Technical design note

Project name	Dunsbury Park - Plot 5		
Design note title	Reserved Matters - drainage condition response		
Document reference	19453-HYD-XX-XX-RP-C-0003		
Author	Alastair Todd		
Revision	P01		
Date	2 August 2023	Approved	☐

This technical note looks to discharge drainage conditions in relation to Reserved Matters application for Phase 1 Plot 5 of APP/17/O1324. This report sets out each condition as worded by Hampshire Lead Local Flood Authority and addressed accordingly.

SURFACE WATER STRATEGY AND STORAGE REQUIREMENTS

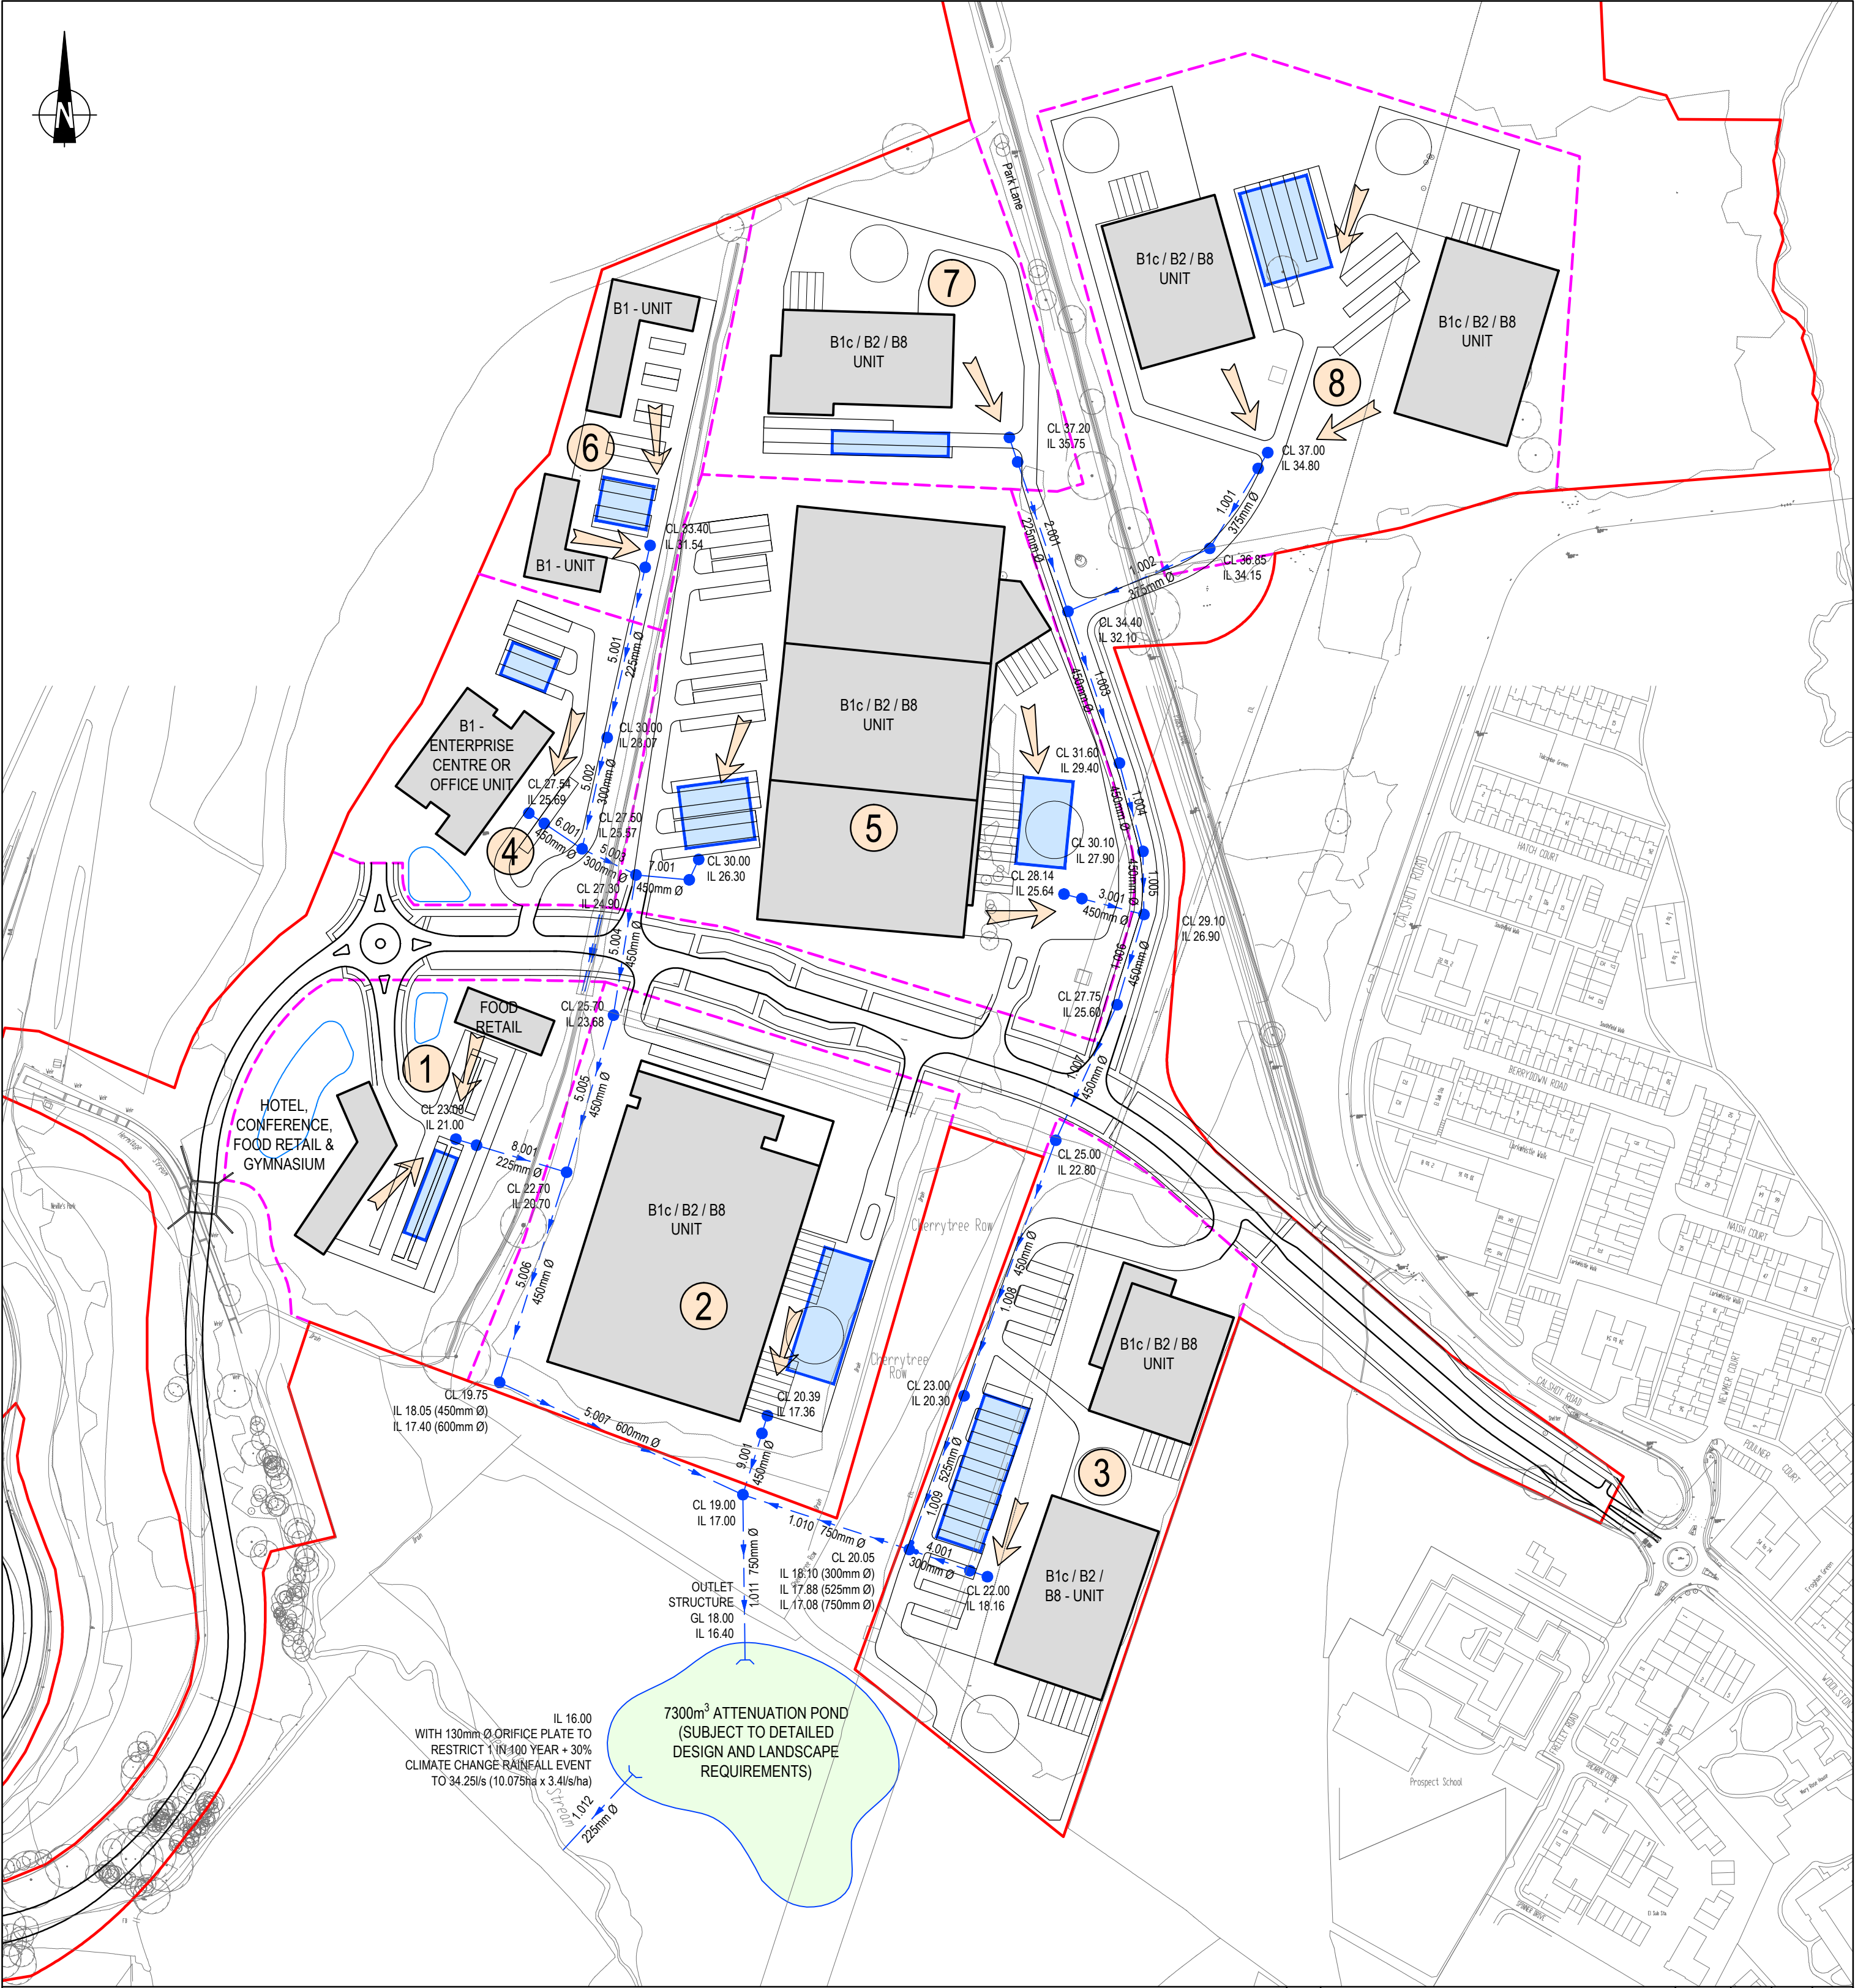
1. Full details of the allowable discharge rates for the impermeable area proposed, in accordance with the PBA Surface Water Drainage and SuDS Strategy (the relevant parts of the report and appendices should be included in this application for reference).

PBA surface water strategy drawings set out proposed discharge rates per plot based on an impermeable area provided at the time of the report. This was based on an allowable discharge rate of 5 x 3.4L/s/ha x impermeable area.

Plot 5 as relates to this application covers the area overlain by Plots 4 & 6 as shown on PBA drawings - **Appendix A** - which have proposed discharge rates of 8.11 L/s and 10.61 L/s respectively, total 18.72 L/s. Final flow controls for the new drainage design are restricted to 7.31 L/s and 11.4 L/s, total 18.71 L/s - **Appendix B** - which matches previously agreed rates as set out in PBA drainage strategy.
